# INTERIOR ENVIRONMENTS PARKING EXPANSION JSP18-51

Public hearing at the request of Interior Environments for approval of Preliminary Site Plan, Wetland Permit and Stormwater Management Plan. The subject property is located in Section 17 north of Grand River Avenue, south of Twelve Mile Road, and east of Wixom Road, and is zoned B-3, General Business. The applicant is proposing to expand the parking lot for an additional 20 spaces, which includes modifications to the existing stormwater detention basin.

## PLANNING REVIEW

**SHEET 2**

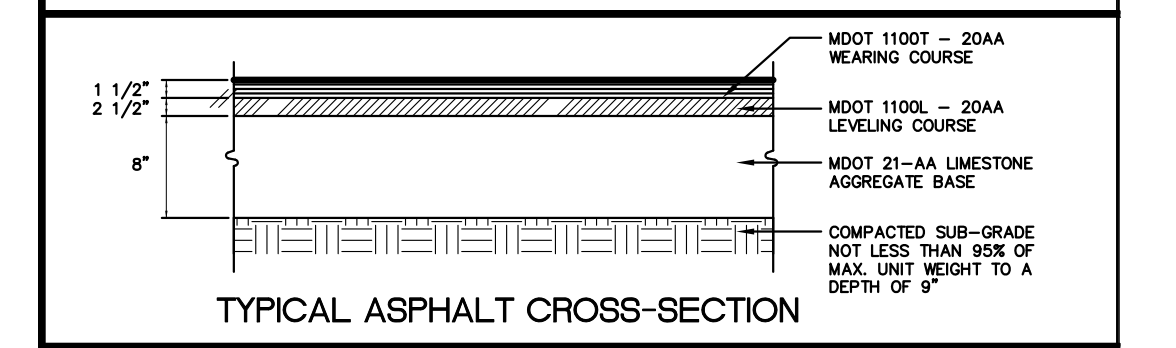
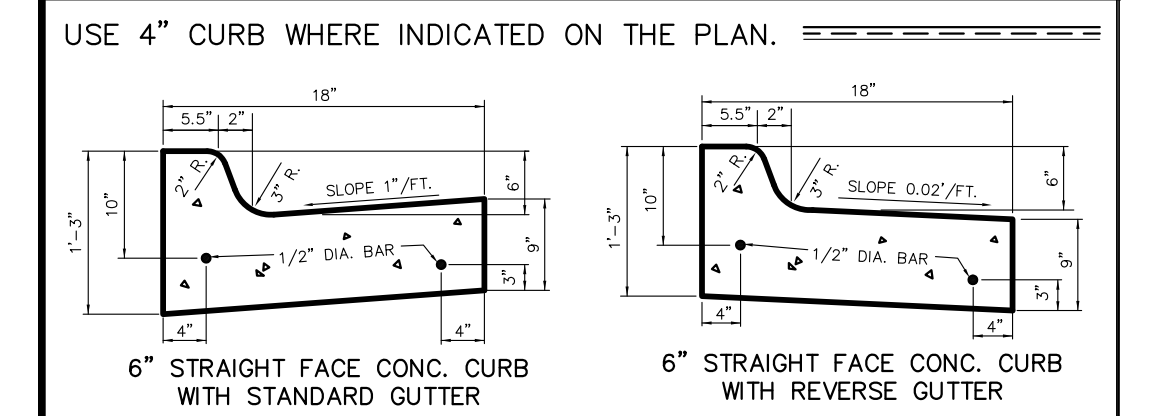
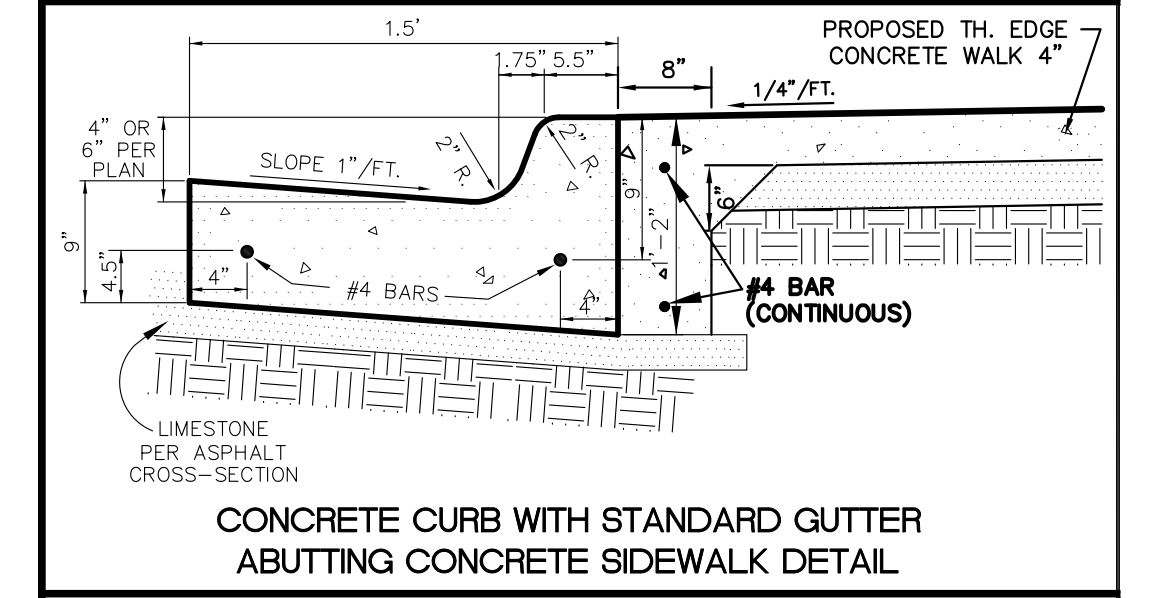
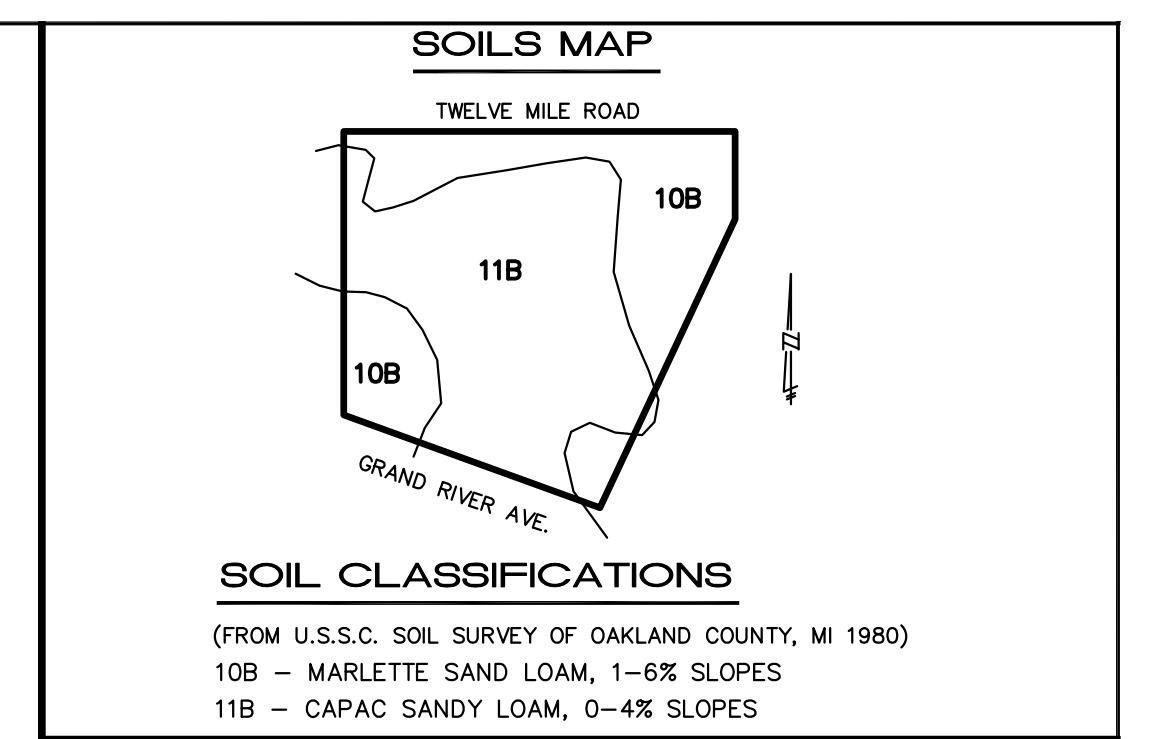
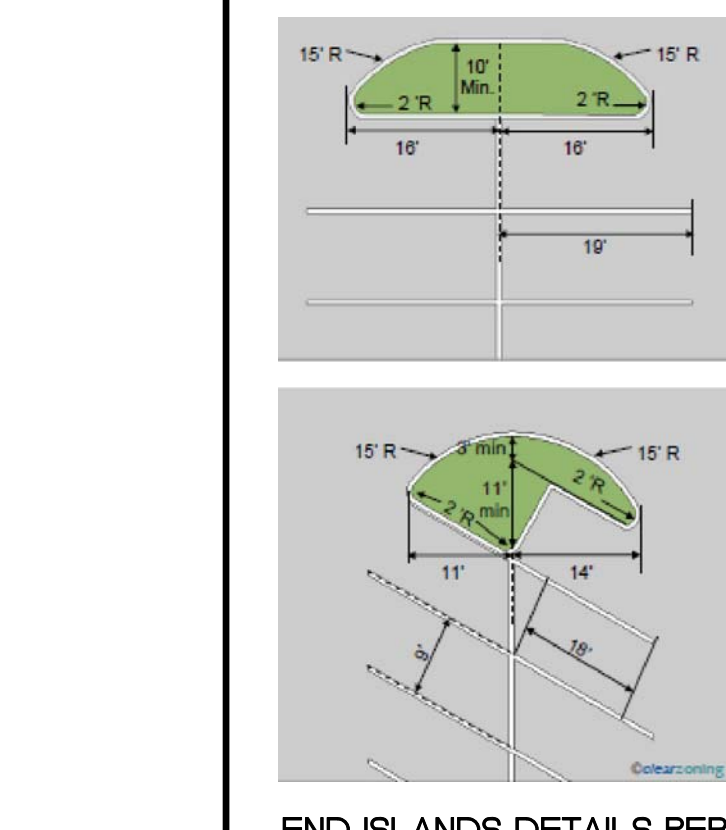
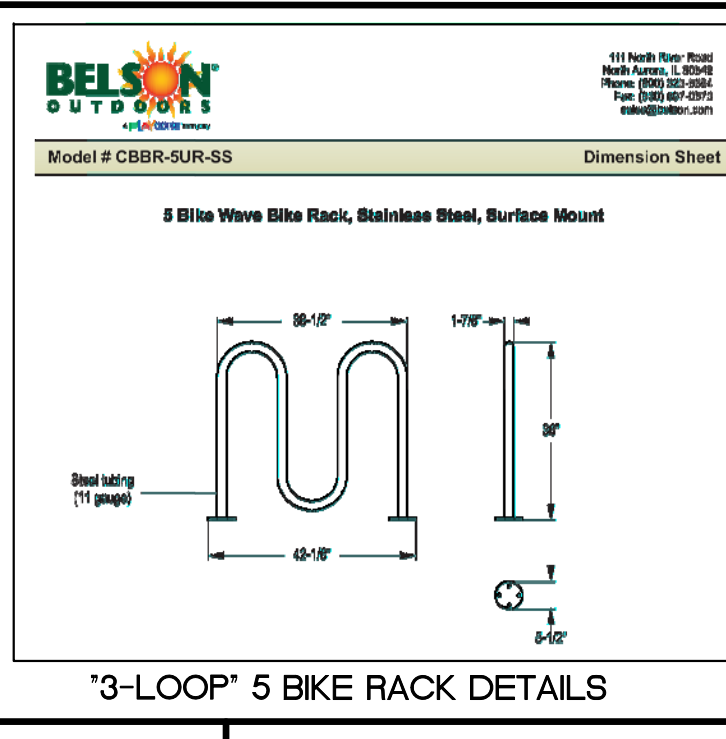
4. Parking Bays: One bay of parking is 19 spaces long, which exceeds the maximum of 15 allowed by the ordinance. **A Planning Commission waiver would be required if the parking bay is to remain as proposed.**

- c. The applicant has generally indicated 19 foot long parking spaces abutting six inch curbs, with a single bay of six (6) 17' parking spaces.
    - i. The four inch curb note should be pointing to the bay of six 17' parking spaces on sheet 2.

**Figure 1.** City of Novi Regulated Wetland & Woodland Map (approximate parcel boundary shown in red). Regulated Woodland areas are shown in green and Regulated Wetland areas are shown in blue.

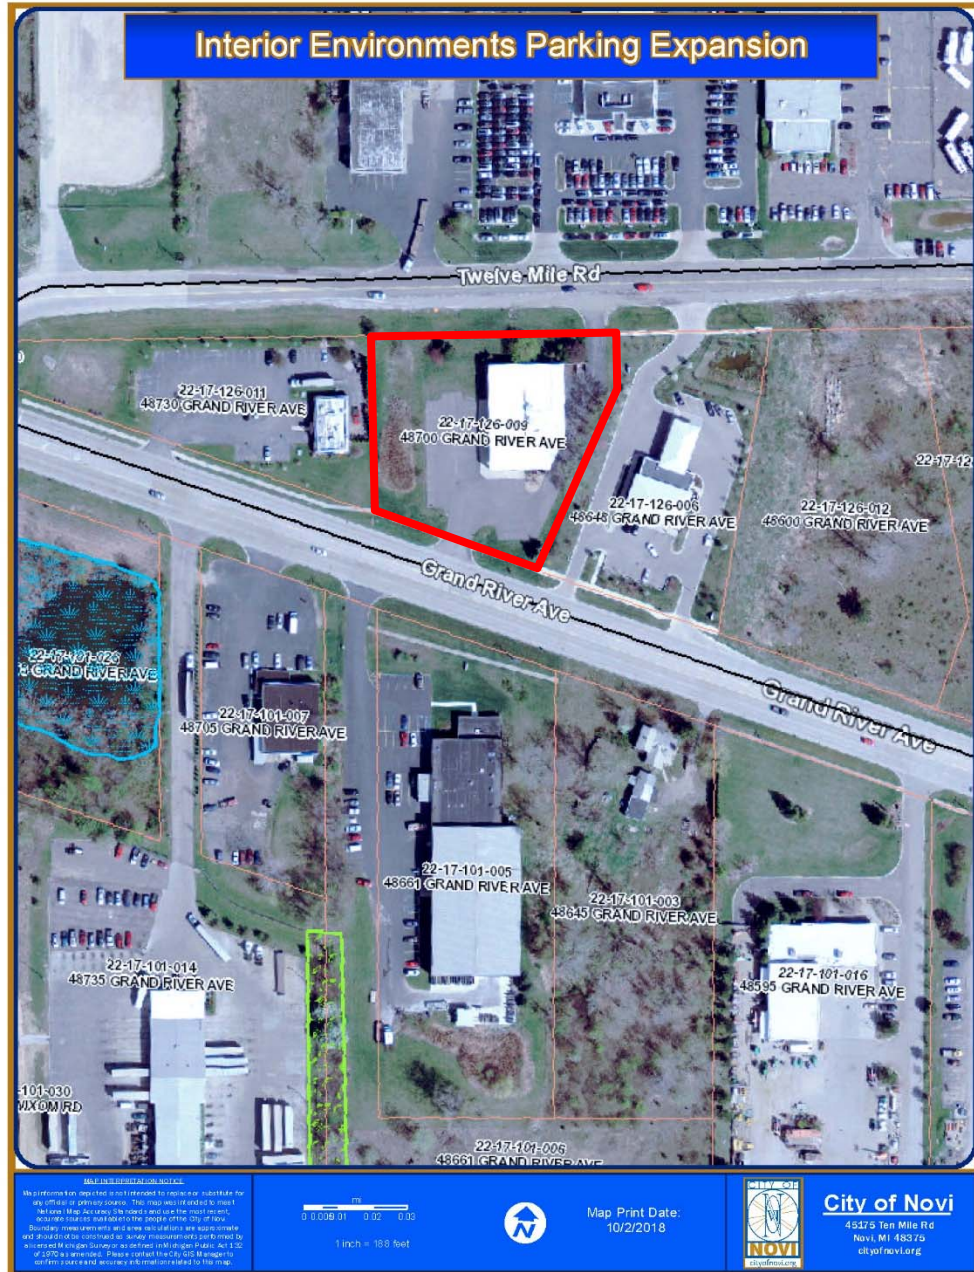
The current site layout proposes to modify the size of the existing stormwater detention basin (i.e., watercourse). As noted above, this is detailed on the *Stormwater Management Plan* (Sheet 3). The proposed impacts to the existing stormwater detention basin (i.e., watercourse) are indicated on that sheet and are summarized below:
